CHANGE ORDER

Project Name: **Haverhill Consentino Middle School** CO No. **21**

Architect's Project No. **21-0818**

See attached list of 8 item(s) for a total of **\$ 25,661.94**

TITLE:
M5 SERIES BDA
INSTALLATION
AND WIRING

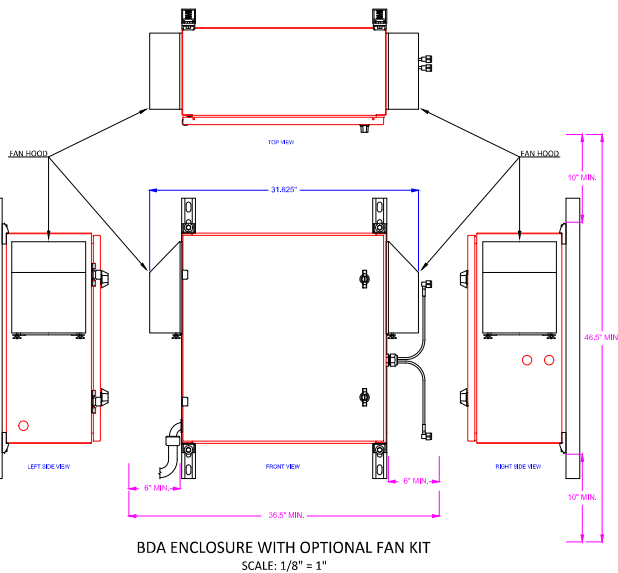
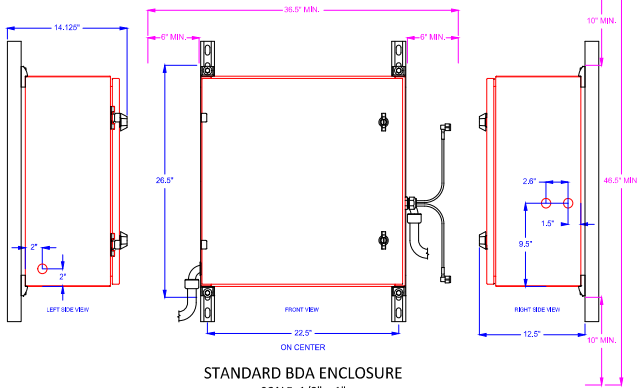
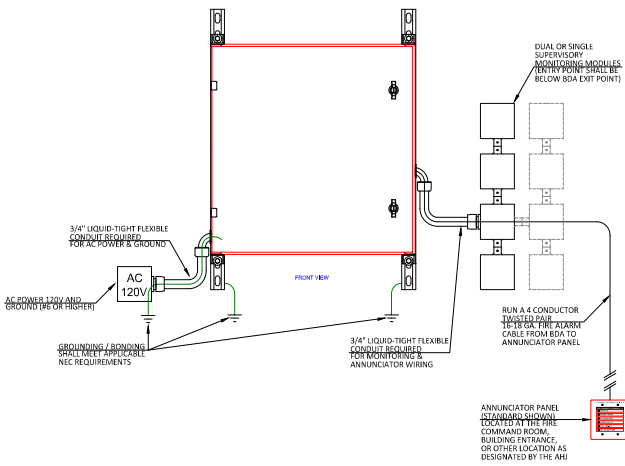
- The Approved Submittal for the BDA System call for three (3) Donor Antennas located in three separate locations on the Roof of the building.
- At the time of WJGEI preparing their bid for the project, we would not have been able to determine that there would have been three (3) Donor Antennas, refer to E3.08 Riser Detail which shows two (2) Donor Antennas, and also would not have been able to determine the locations as submitted. Following the Riser Detail we would have determined to locate the two (2) Antennas shown directly above The BDA Closet 4015.

- We have included within this proposal our marked up drawing showing the added length of Conduit and Cable and proposed routing. Also pasted onto this drawing is the Approved locations and BDA Riser.

Project name
Constentino Middle School

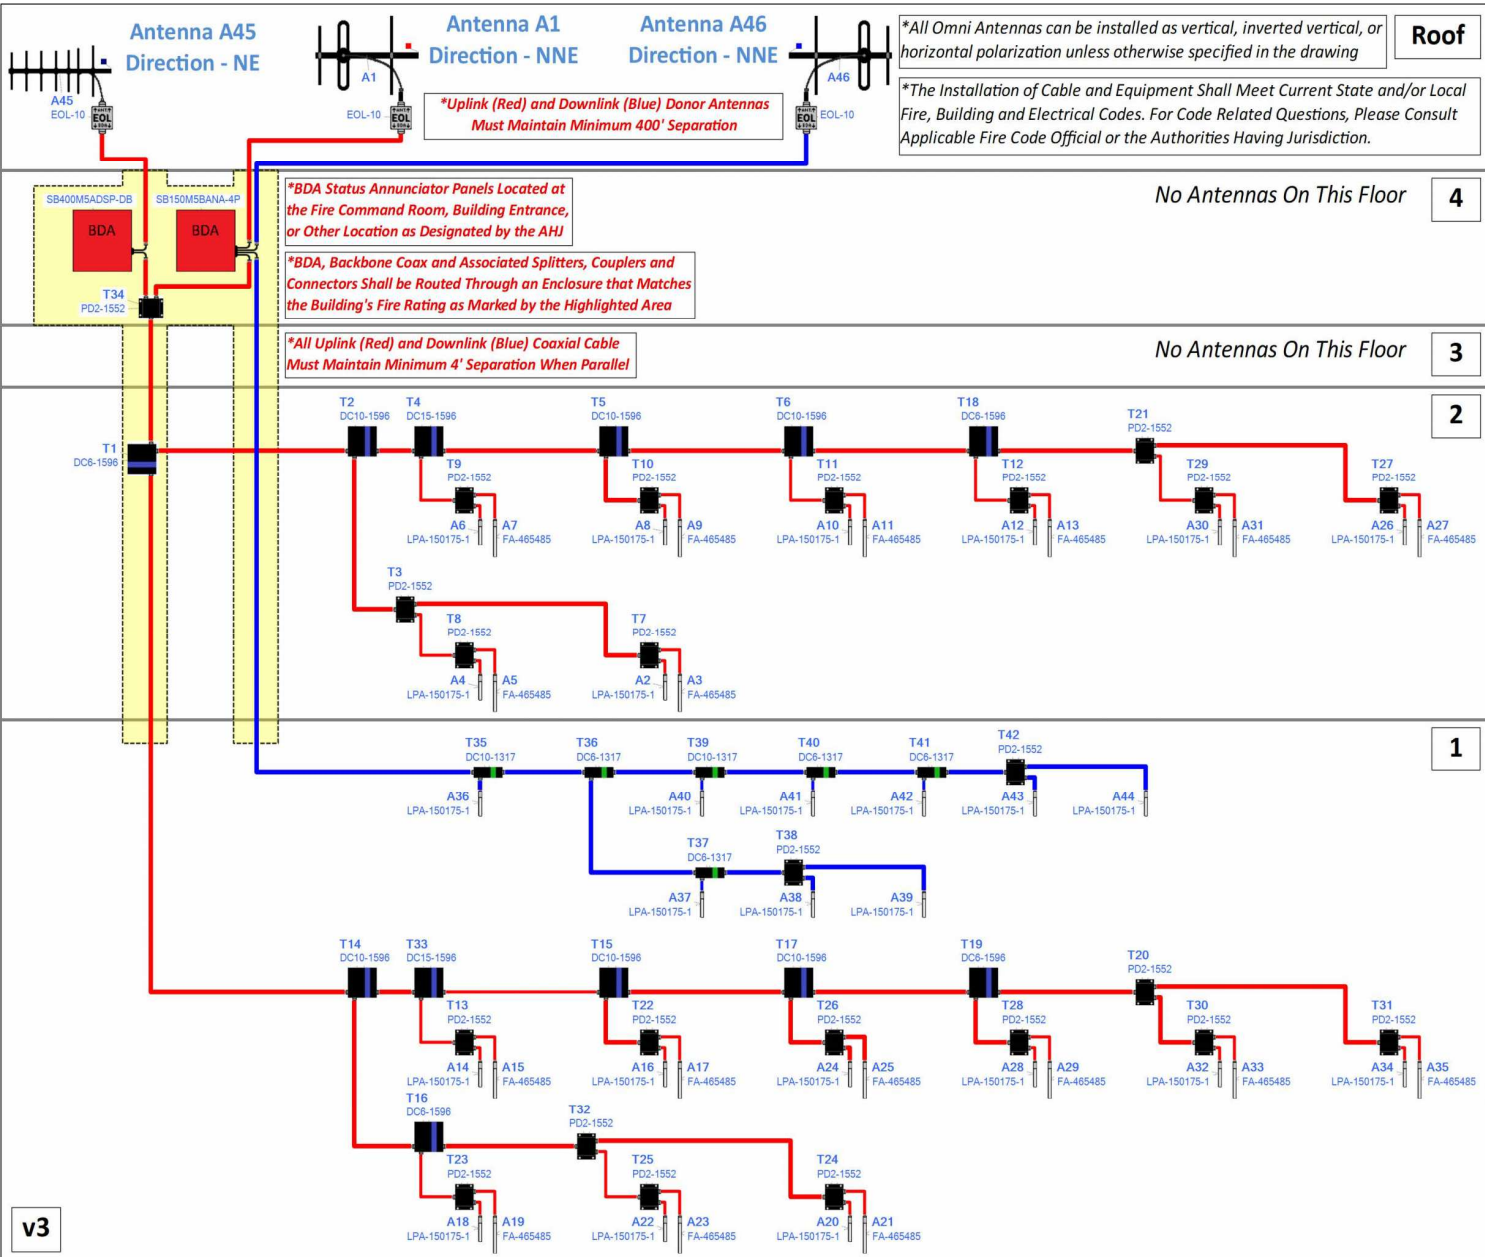
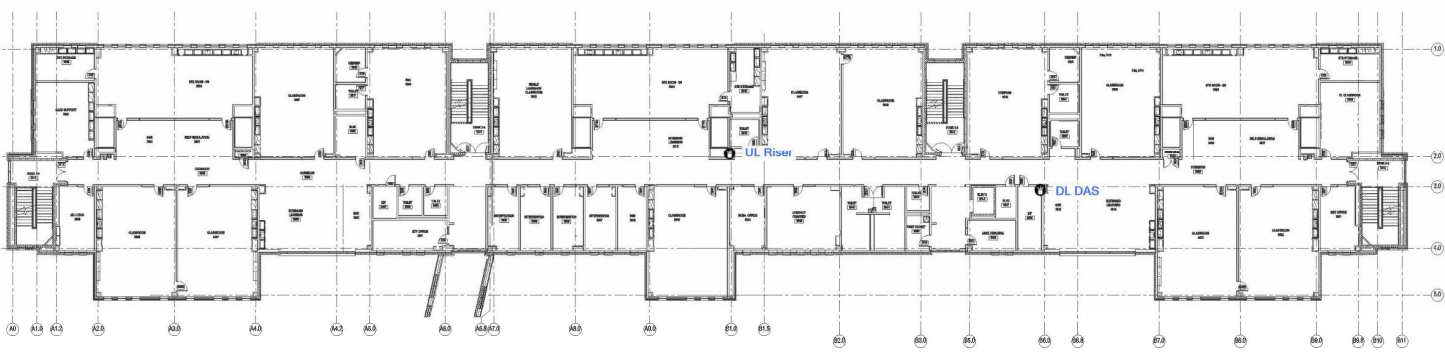
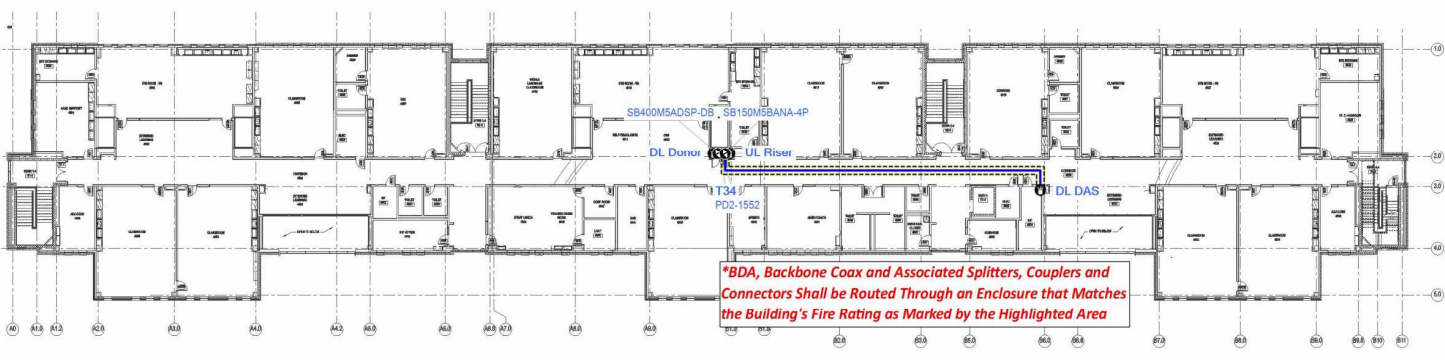
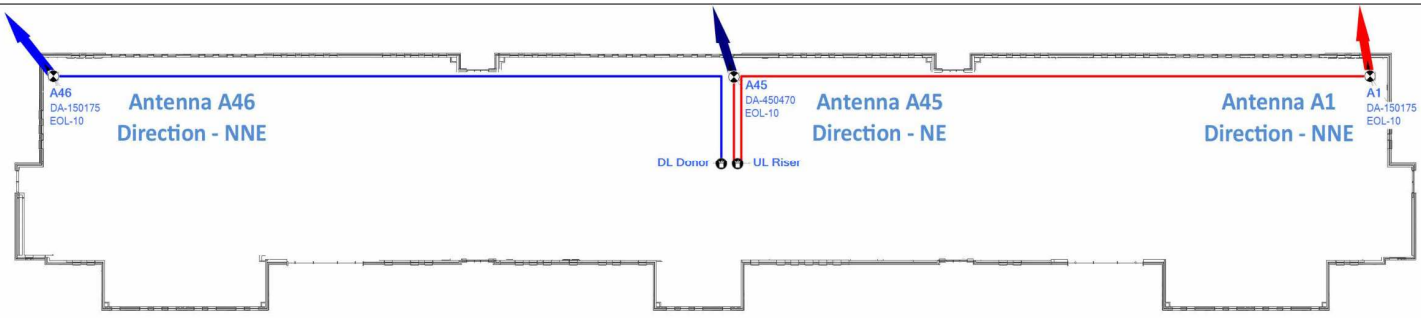
*At the time of WJGEI preparing their bid for the project, we would not have been able to determine that there would have been (3) Donor Antennas, refer to E3.08 Riser Detail which shows (2) Donor Antennas, and also would not have been able to determine the locations as submitted. Following the Riser Detail we would have determined to locate the (2) Antennas shown directly above The BDA Closet 4015.

*We have included within this proposal our marked up drawing showing the added length of Conduit and Cable and proposed routing . Also pasted onto this drawing is the Approved locations and BDA Riser .

PS - Heavy Duty Parallel Arm with Positive Stop

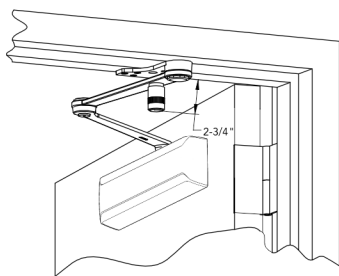
At Area B, Group Toilets, Doors 1109, 2066, 3041, and 4039, replace P10 Heavy Duty Parallel arms with PH10 HD Hold-Open arms (25-PH10-EN). Arm to be set to 180 degrees to put doors up against corridor walls.
